Plan Commission Meeting Date: July 14, 2014

Public Hearing and Prehearing Conference on Request by Monona Parks & Recreation Review of Proposed Improvements to Lottes Park, 400 W Broadway, Including a Restroom Facility and Fish Cleaning Station, Parking Lot Grading and Striping, Boardwalk Extension, and Boat Launch Facilities.

2-011-2014

WEST ELEVATION

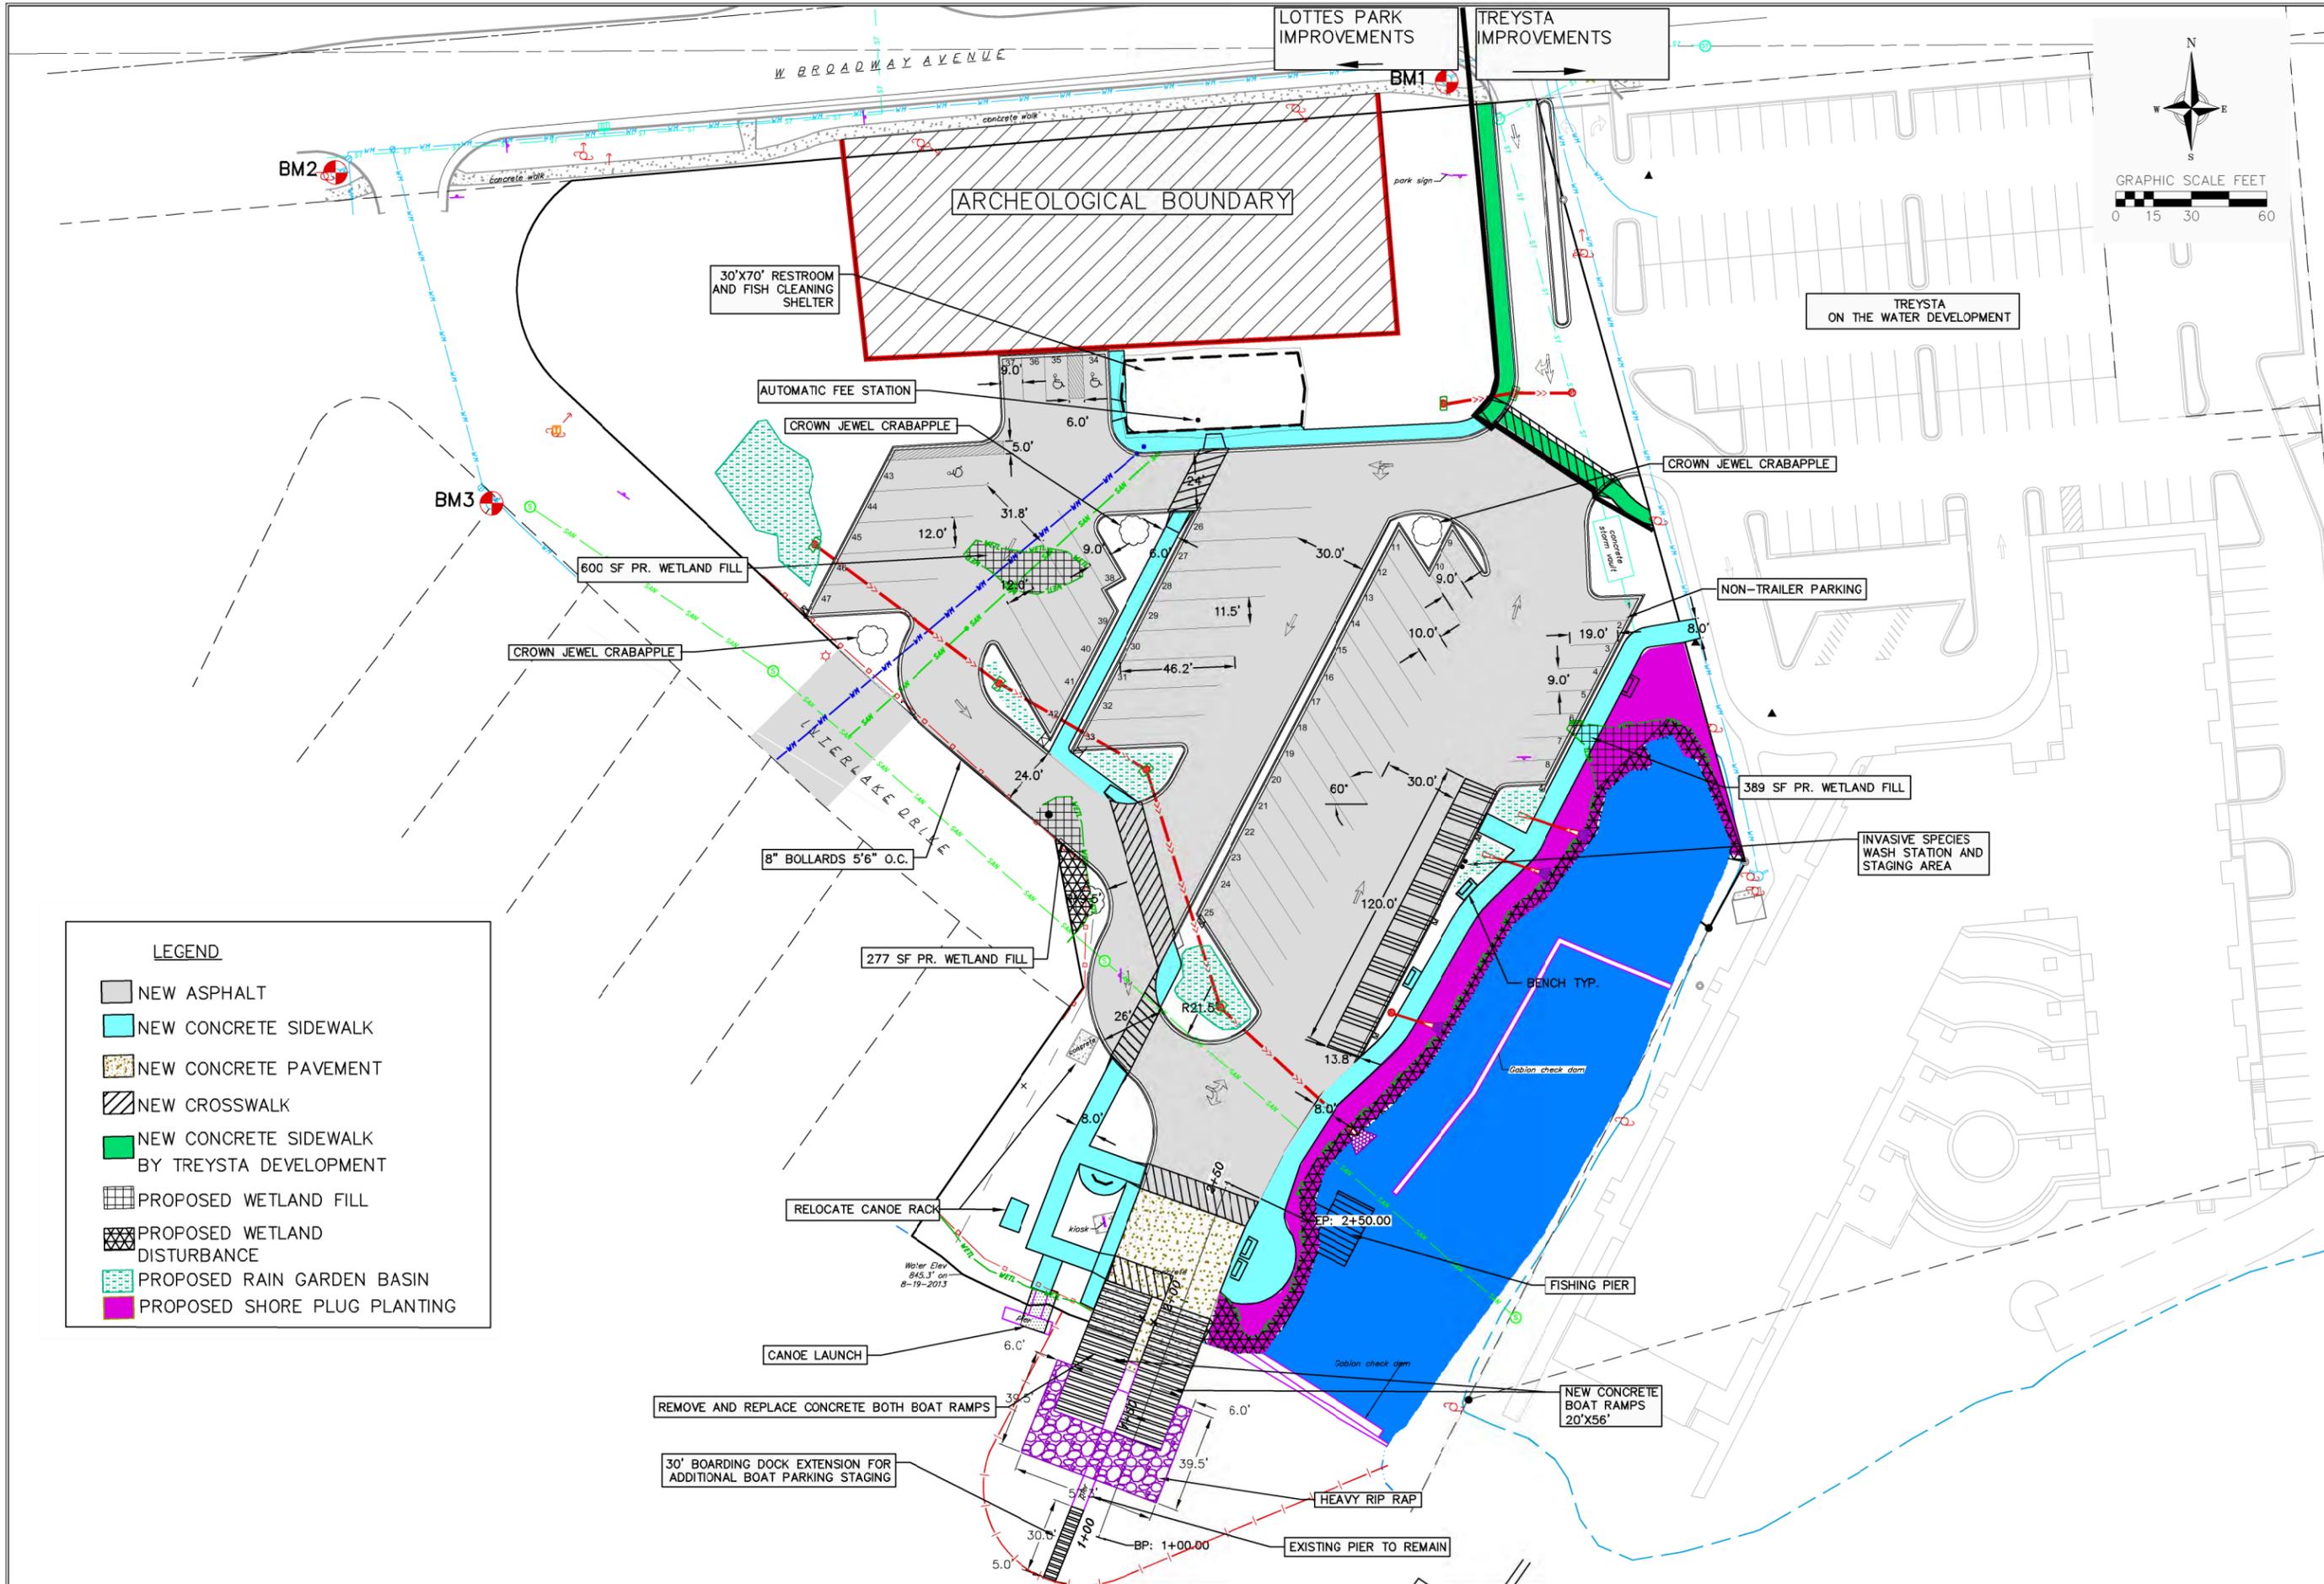
Building materials include split-face concrete block (two different colors), cedar lap siding, and an asphalt single roof, along with a skylight, and glazed windows. The design is consistent on all four sides. The footprint of the building is 30’x70’ (2,100 SF).
